Newfield Construction, Inc.

BULLETIN NO. 2R

Dillon Stadium – Phase 2, Hartford, CT

Clarifications

FOUNDATION PLAN
SCALE: 3/32" = 1'-0"

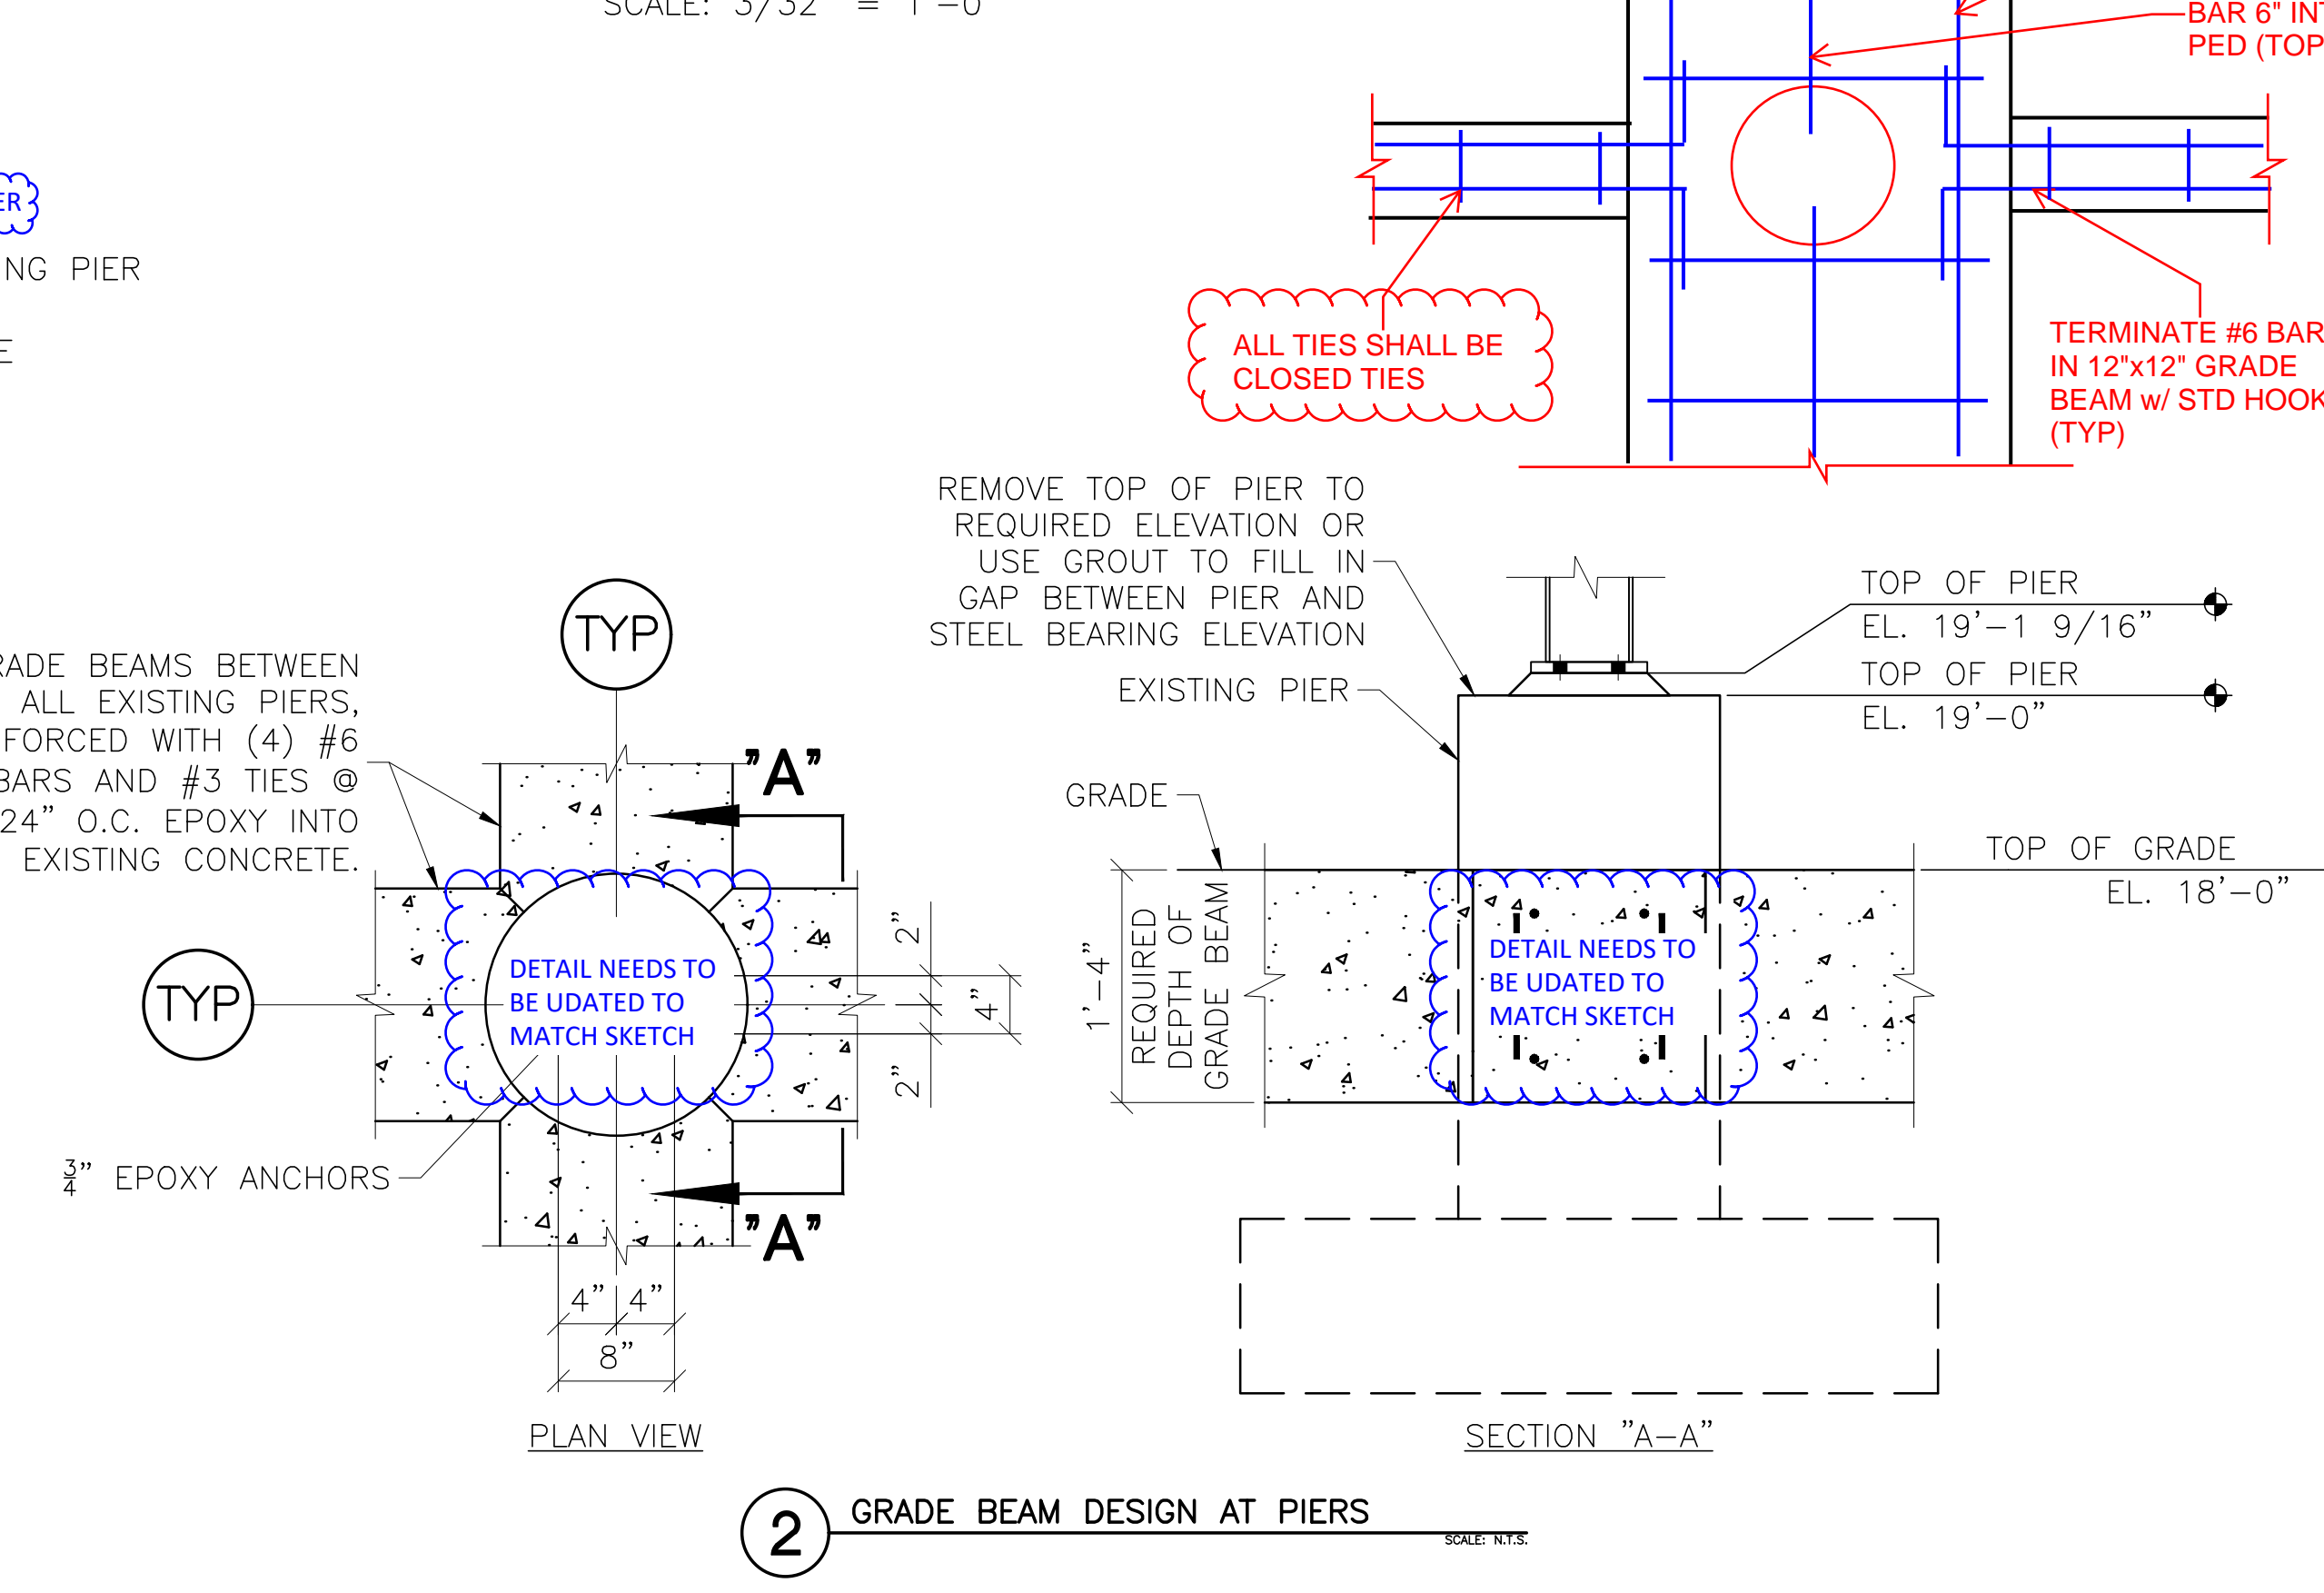
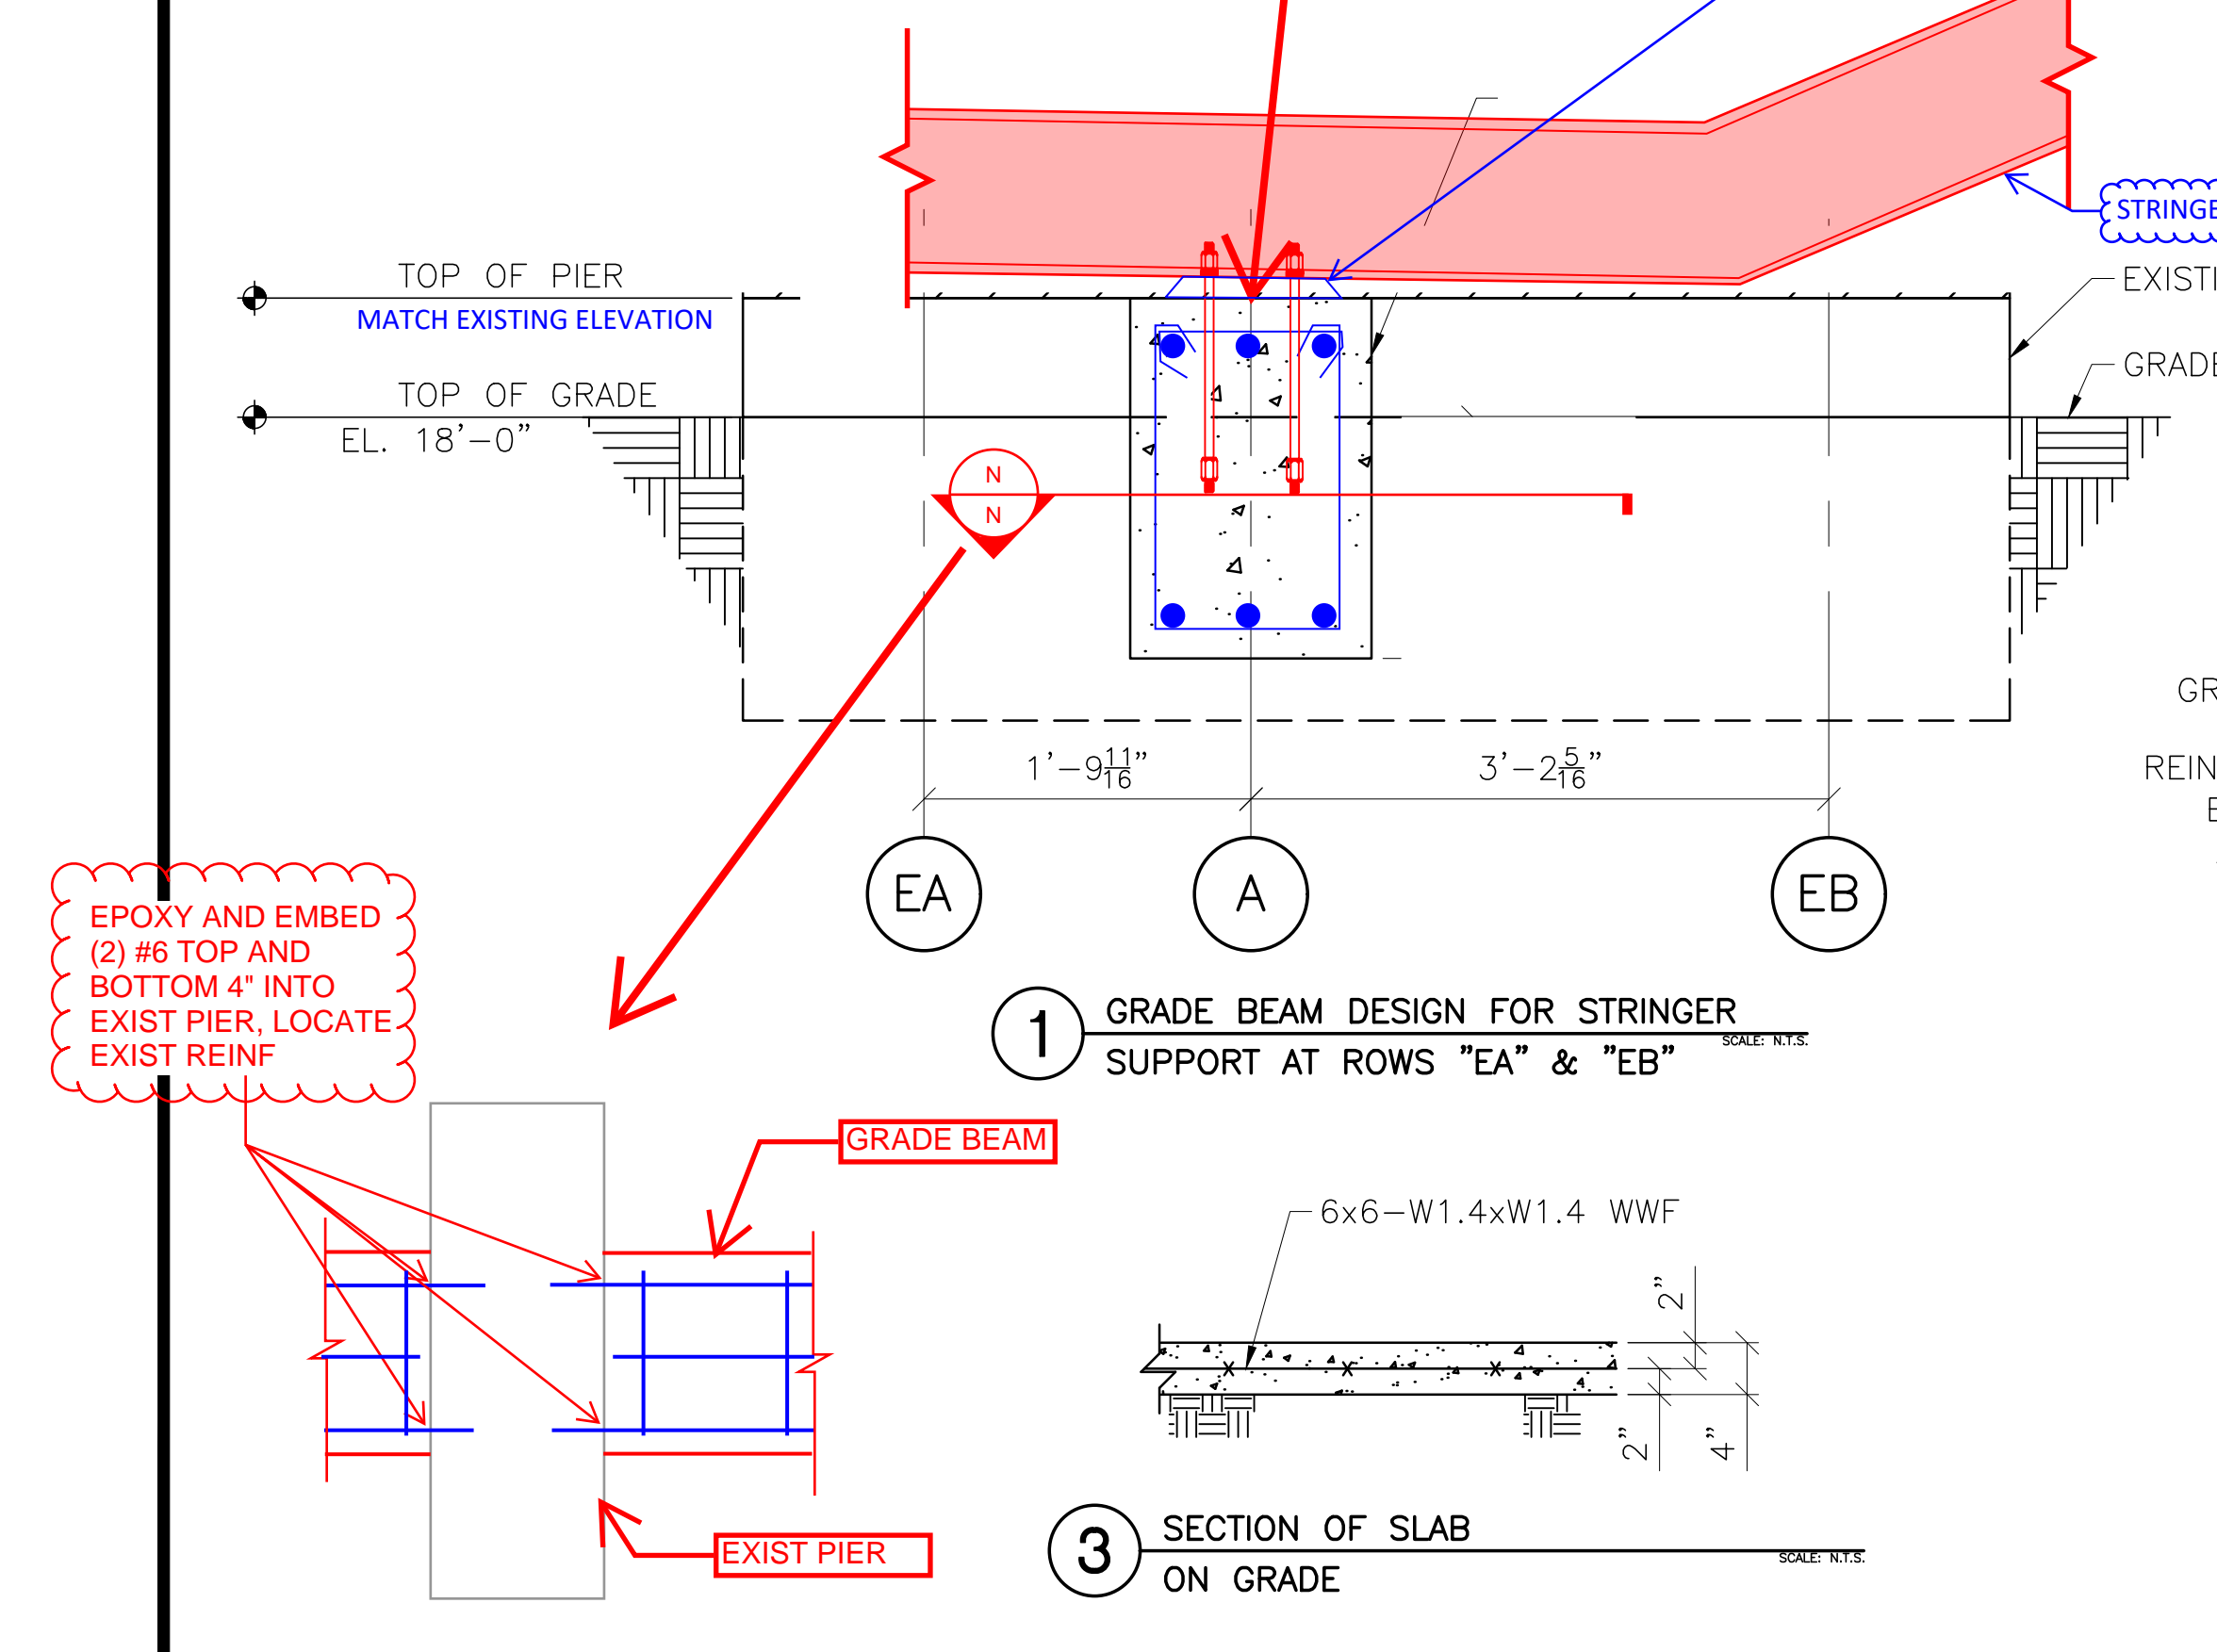
3. Section 00 2400 Bid Packages, Part B Bid Package 2.2 Concrete, Bid Package Notes:
Add Note A2R.01: Reference Bulletin 1R. Disregard PB SK-02 East Bleacher Grade Beams.
Add Note A2R.02: Reference Drawing 1-0 (attached). Include all grade beams at the East bleacher existing piers as shown on the plan. In Detail 1 change the elevation of the top of the grade beam to be flush with the top of grade. All grade beams will be poured on a stone base provided by others. All reinforcing steel will be furnished and delivered by others, installed by BP 2.2 Concrete. Include drilling and epoxy at existing piers/foundations. Include cast in place anchor bolts (2 sets of 4 bolts) to be provided by others between each column line along A Line. Provide a survey of the anchor bolts. Include concrete slabs (4) as shown. Prep for the concrete slabs is by others. Anchor bolts will be furnished and installed by others. Include grouting base plates at A Line and at all existing piers after the bleacher structure is installed (there are no leveling plates).

Add Note A2R.03: Reference Drawing C-200. Include (4) concrete pads at the West bleachers similar (same size) to the concrete pads at the East bleachers shown on Drawing 1-0. Prep and reinforcing steel are by others. The concrete pad shown at the center of the West bleachers is by others.
Add Note A2R.04: Reference drawing S602. Include grouting base plates at all column locations after the bleacher structure is installed (there are no leveling plates).

GOLD Xi SERIES COMMERCIAL ELECTRIC WATER HEATER

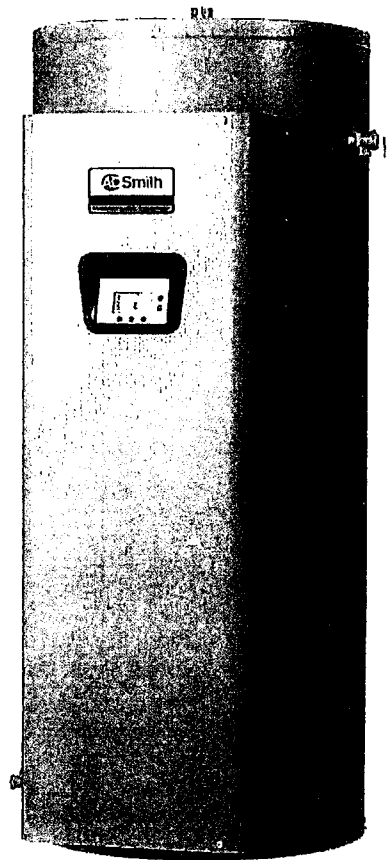
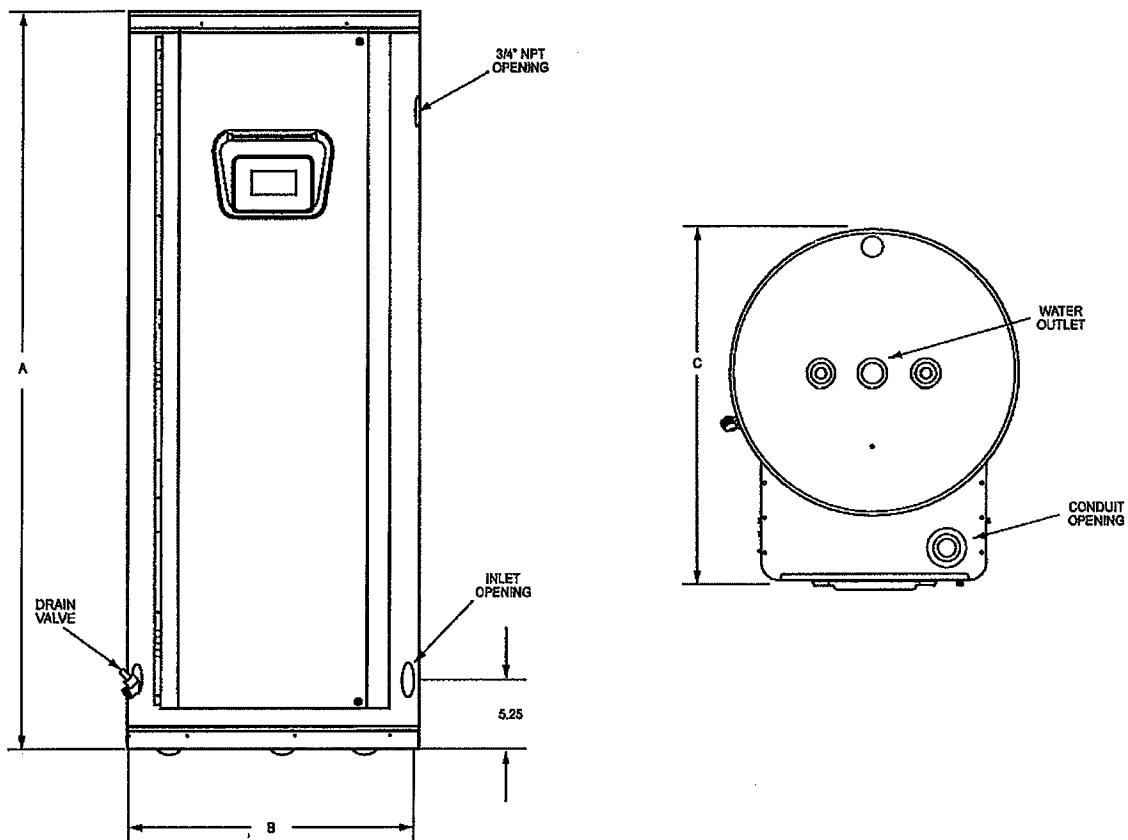
There are two water heaters shown in Building B; however, the type of water heater is not designated. Please confirm.

Dustin:
Answer to RFI # PB-PH2R-005
Water Heater Shall be AO Smith Commercial Electric Water Heater # DVE-52/6 KW/50 Gallon. (2) Required see Plumbing drawing # P-101 B. See Enclosed Cut Sheet.
Thanks
George
George Civitelli
Project Manager / Senior Plumbing/FP Engineer
Innovative Engineering Services, LLC
33 North Plains Industrial Rd.
Wallingford, CT 06492
Tel: 203.467.4370 ext. 210]
Fax: 203.793.7729
Cell: 203-499-7870
GCivitelli@iesllc.biz http://www.iesllc.biz
CT Small Business Enterprise
